## REFERRAL REPORT

Report Date: April 28, 2020  
Contact: Theresa O'Donnell  
Contact No.: 604.673.8434  
RTS No.: 13792  
VanRIMS No.: 08-2000-20  
Meeting Date: April 28, 2020

SUBJECT: CD-1 Rezoning: 105-125 West 49th Avenue

**Figure 2: Site Plan**

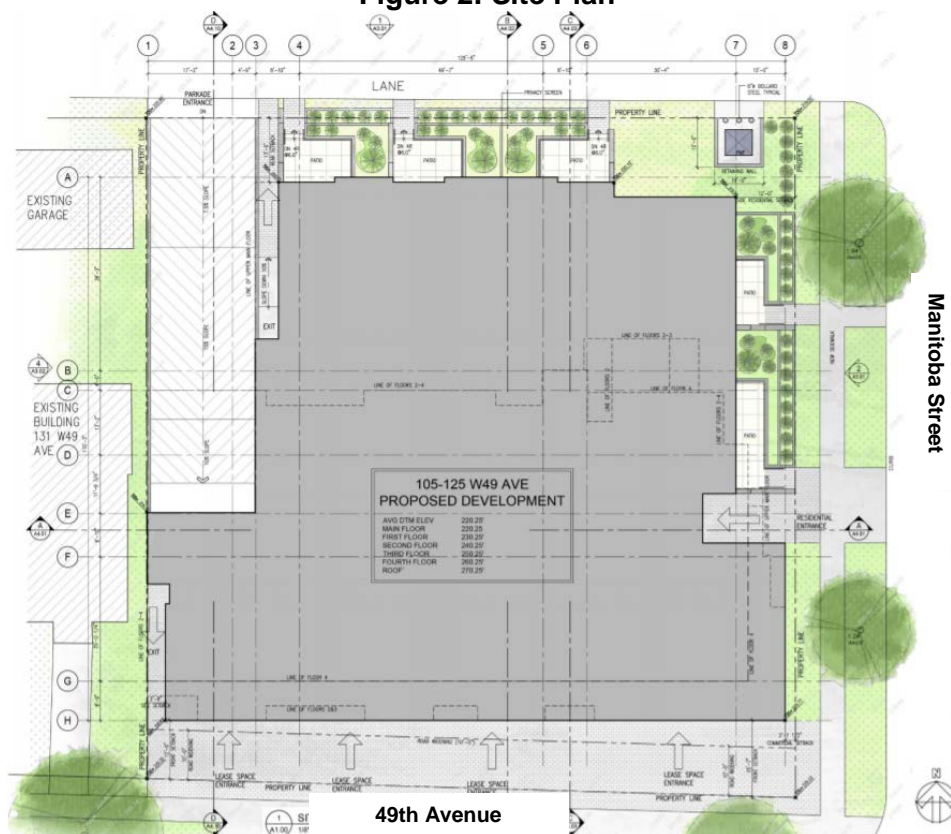
- (c) Provide adequate screening of PMT from lane and Manitoba Street (see landscape condition #6a).
- 4. Design development to adopt a bird-friendly strategy for the building's design.

- 6. Design development to enhance, buffer and articulate landscaping at ground level and public realm interface through the following:
  - (a) Provide a landscape setback of minimum 0.9 m (3 ft.) wide between parking ramp and the west property line to buffer the ramp from the neighbouring property to the west;
  - (b) Provide a more pedestrian friendly and active street public life on 49th Avenue, by adding planter beds and landscape articulation more in keeping with the residential character of the street;
  - (c) Provide a more substantial landscape interface fronting Manitoba Street;
  - (d) Improve the lane interface by providing landscape buffering of the PMT and creating a usable common outdoor space between private patios and PMT at the lane.
